UNITED STATES DEPARTMENT OF COMMERCE United States Patent and Trademark Office Address: COMMISSIONER FOR PATENTS P.O. Box 1450 Alexandria, Virginia 22313-1450 www.uspto.gov

| APPLICATION NO. | FILING DATE | FIRST NAMED INVENTOR | ATTORNEY DOCKET NO. | CONFIRMATION NO. |
|---|-----------------------------------|----------------------|---------------------|------------------|
| 10/613,605 | 07/03/2003 | David DeRogatis | 24170759.16 | 7300 |

| | Application No. | Applicant(s) | | | | |
|--|---|---|--|--|--|--|
| Office Action Summary | Examiner | Art Unit | | | | |

DETAILED ACTION

Barton, 2,363,477

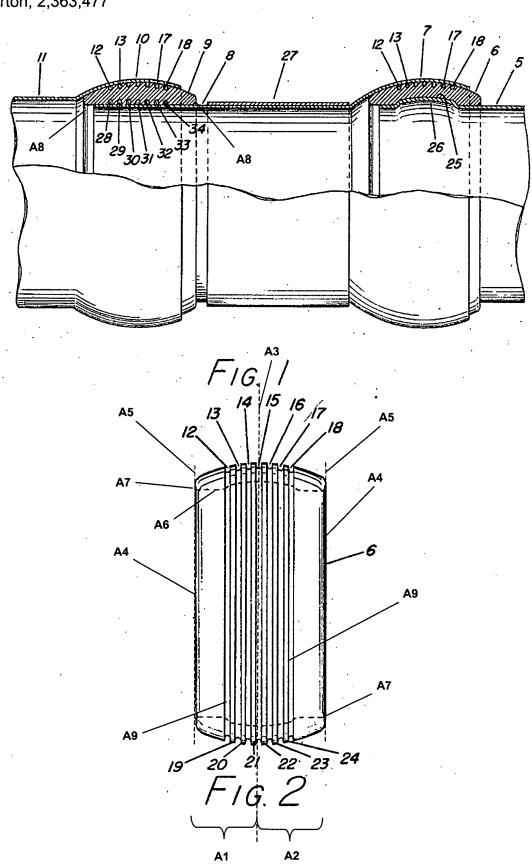
Regarding claim 65, Barton discloses, in Figures 1 and 2, a plug fastener comprising a first hemispheroidal portion A1 (see marked-up attachment) and a second hemispheroidal portion A2 opposed to the first hemispheroidal portion A1. The first

hemispheroidal portion A1 is symmetrical to the second hemispheroidal portion A2 about their plane of opposition A3. Each hemispheroidal portion A1,A2 comprises a mating surface A4 respectively truncating the hemispheroidal portions A1,A2. The mating surface A4 defines a mating plane A5 parallel to the plane of opposition A3. The mating planes A5 of the first and second hemispheroidal portions A1,A2 are opposite from each other across the plane of opposition A3. Ridges 19-24 extend outwardly from the respective hemispheroidal portions between the mating surfaces A4 and the plane of opposition A3. An aperture A6 is defined within and extending through the first and second hemispheroidal portions A1,A2. The aperture A6 has a first countersink A8 (note that Figure 1 show this countersink which allows ease of insertion of a fastener 8) defined within an opening A7 in the first mating surface A4 and a second countersink A6 defined within an opening A7 in the second mating surface A4.

Regarding claim 71, the plug fastener further comprises an elongate fastener 8 disposed in the aperture A6.

Regarding claim 75, the ridges **19,20** on the first hemispheroidal portion A**1** are directed towards the ridges **23,24** on the second hemispheroidal portion A**2**.

Regarding claim 77, the ridges **19-24** outwardly extend from corresponding exterior surfaces A**9** of the hemispheroidal portions.

Regarding claim 80, the aperture **A6** is substantially cylindrical between the countersinks **A8**.

Regarding claim 81, the aperture **A6** is substantially perpendicular with respect to the pane of opposition **A3**.
